City of Huron Agenda for the Planning Commission/DRB Wednesday, May 21, 2025 5:00pm.

Public Hearing: General Development Concept Plan- Huron Harbor (former ConAgra Site) Cleveland Road E. PPN42-61270.001 General Development Concept Plan Review #1

RE: Public Hearing- General Development Concept Plan- Huron Harbor (ConAgra site)

Zoning District: MU-GD **Parcel No.: 42**-61270.001 **Lot Size:** 11.29 acres

Abingdon 1649 SQFT :: 16' x 40'

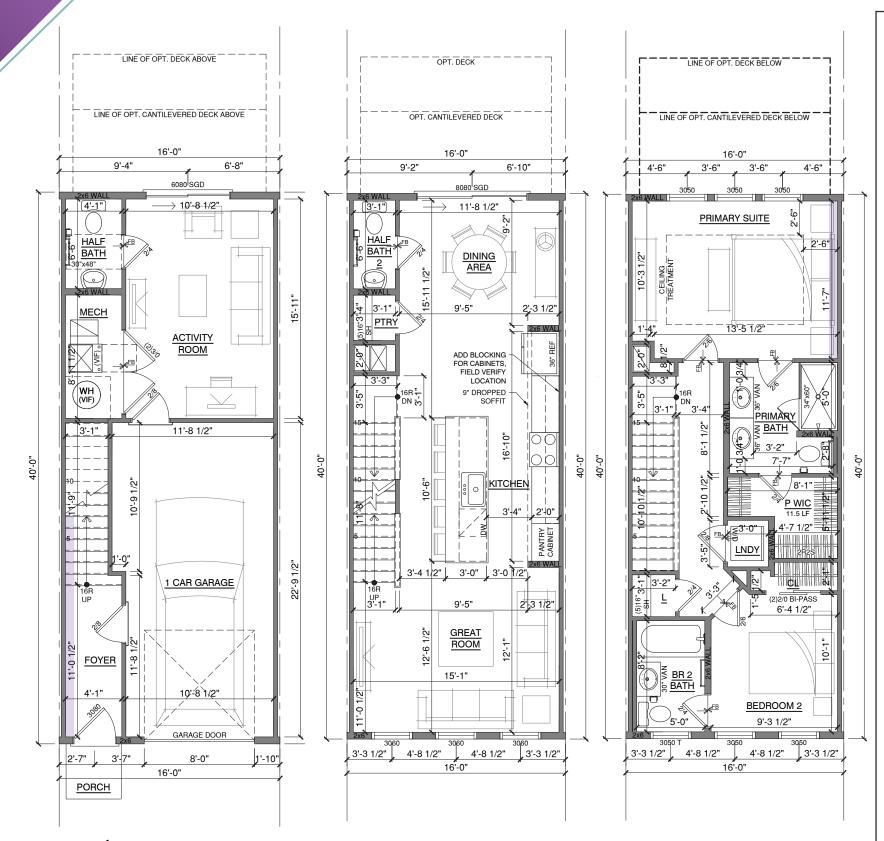
Staff believes the similar elevation examples meet the intent and requirements of 1127.06 (a) General Criteria and 1127.06 (b) Criteria for the Design of Buildings:

- •Design shall be appropriate and compatible in conformance with the character established by the City's Master Plan.
- •The exterior designs are attractive with nautical design elements, complimentary colors and materials, while still providing distinct individual unit characteristics and appeal.
- •Sidewalks/access to pedestrians and bicycles are reflected within the plan to get from the interior areas to the perimeter pathway.

Final Design Elevations will be included for the next meeting.
